ADDENDUM NO. CC-2

NORTHEAST COMMUNITY COLLEGE
HAIL DAMAGE ROOF REPAIR - BID SET TWO
801 East Benjamin Avenue
Norfolk, NE 68702-0469
BCDM Project No. 3500-12

BCDM Architects
1015 North 98th Street, Suite 300
Omaha, Nebraska 68114

07 October 2016

3500-12	DRAWING REFERENCED: SB1-1	ATTACHMENT
10/07/2016		ASD-08

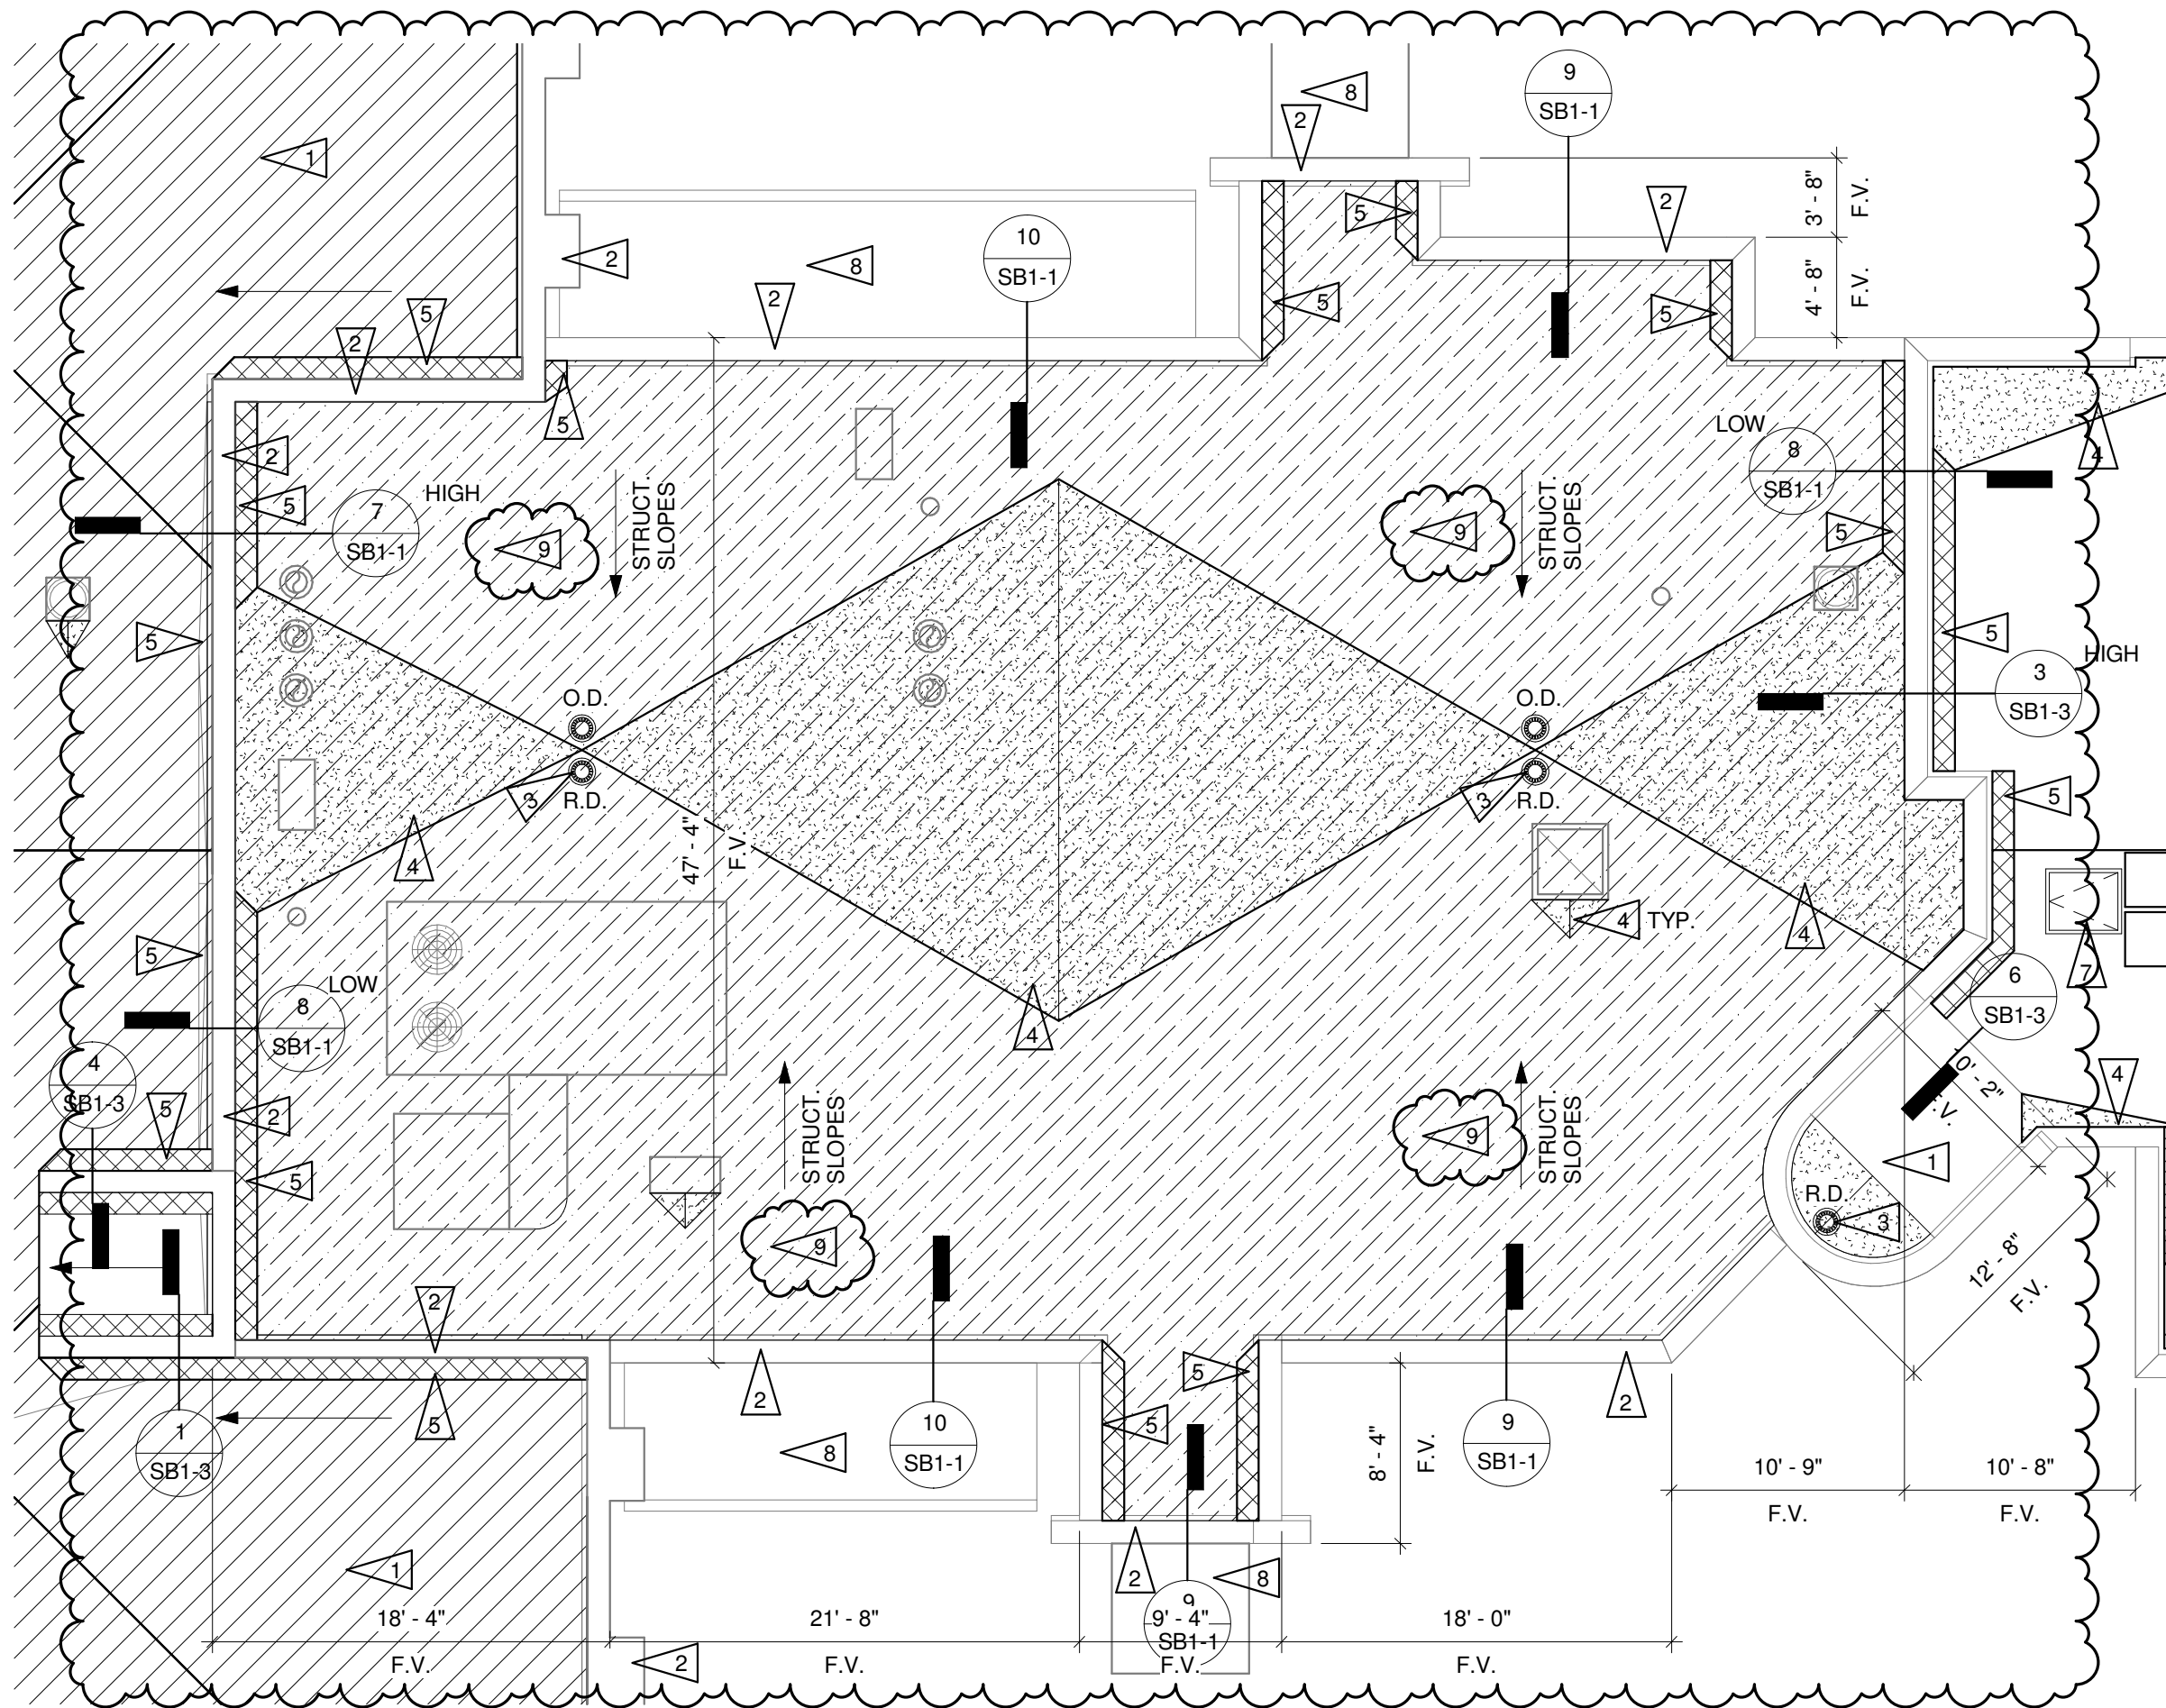
- a. At Detail 1 “Roof Demolition Plan”, modify the roof plan at the lower roof on Burkhardt Hall by changing flag note 1 to flag note 8 as shown on ASD-08.
- b. At Roofing Demolition Flag Notes, add Flag Note No. 8 to read “Remove roofing membrane down to existing roof insulation (roof insulation to remain)”.

ED1-1

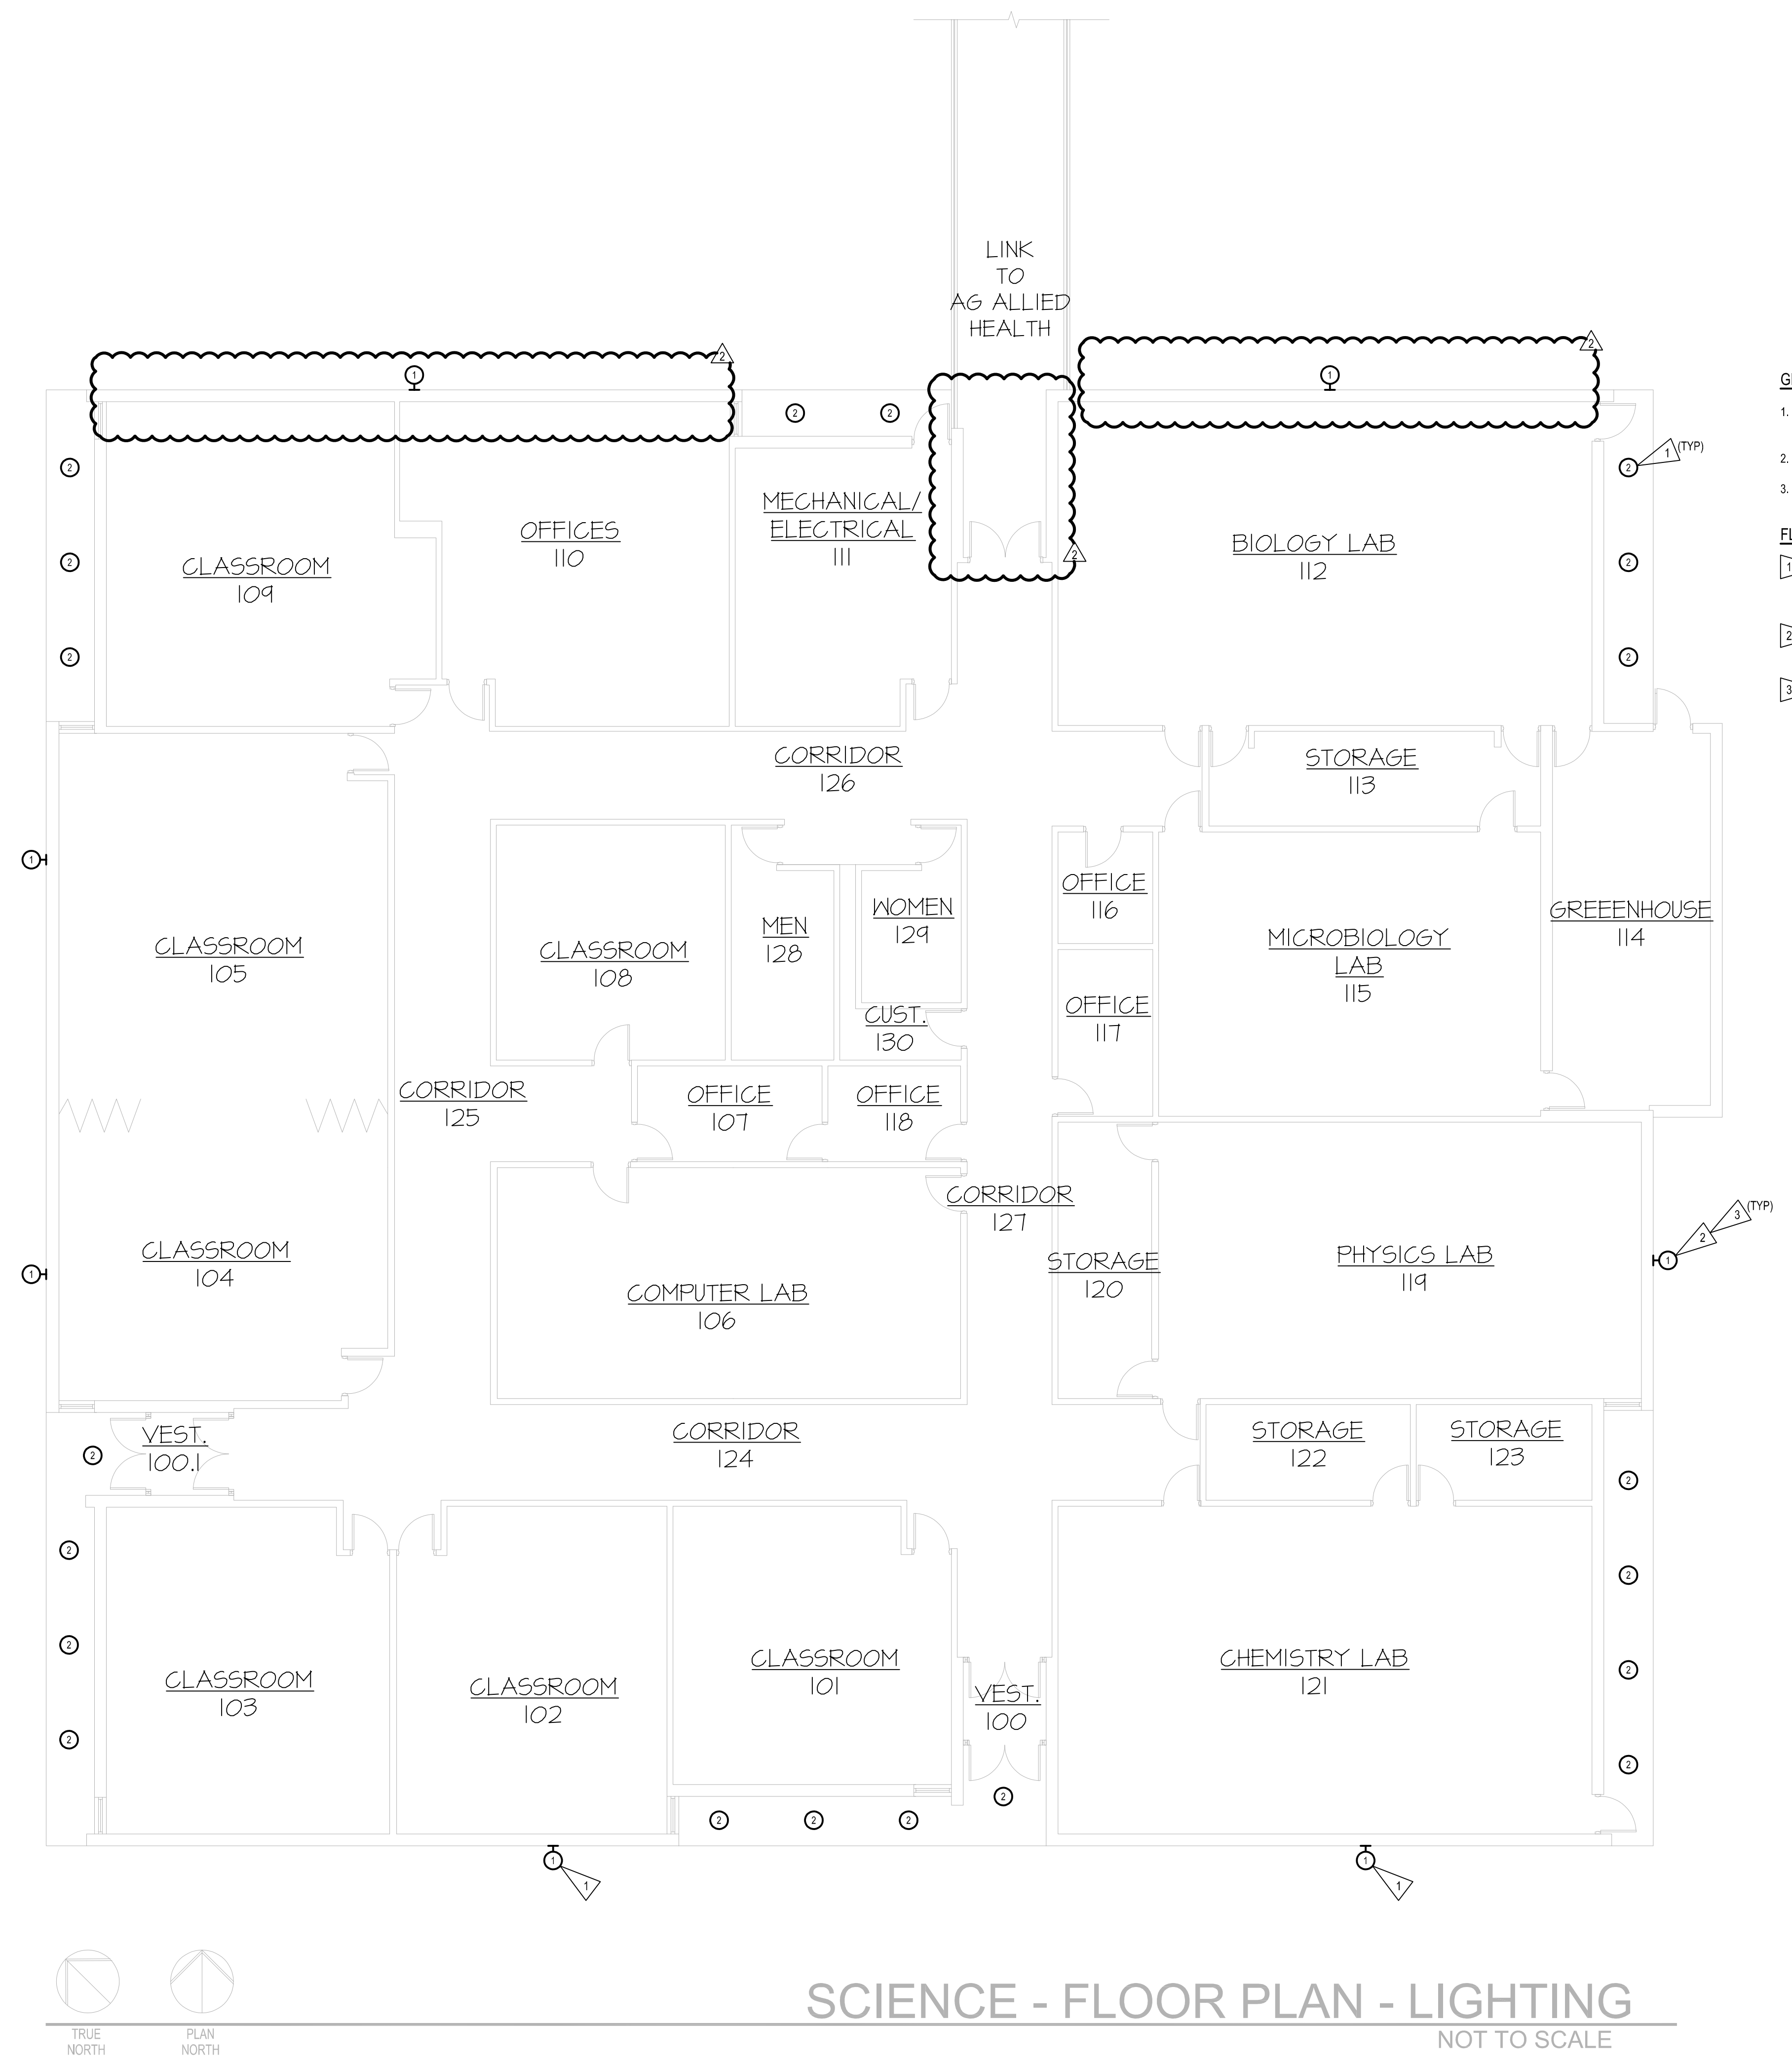
1. Sheet ED1-1 – Science Building – Lighting Demolition
 - a. Do not remove downlights in link to AG Allied Health building. See attached revised drawing for changes to demolition work.
2. Sheet ED1-2 – AG Allied Health – Lighting Demolition
 - a. Do not remove exterior downlights on this building. See attached revised drawing for changes to demolition work.
3. Sheet E1-1 – Science Building - Lighting
 - a. Revise lighting on north side of building. See attached revised drawing for changes to new lighting plan.
4. Sheet E1-2 – AG Allied Health – Lighting
 - a. Revise lighting plan around exterior building. See attached revised drawing for changes to new lighting plan.
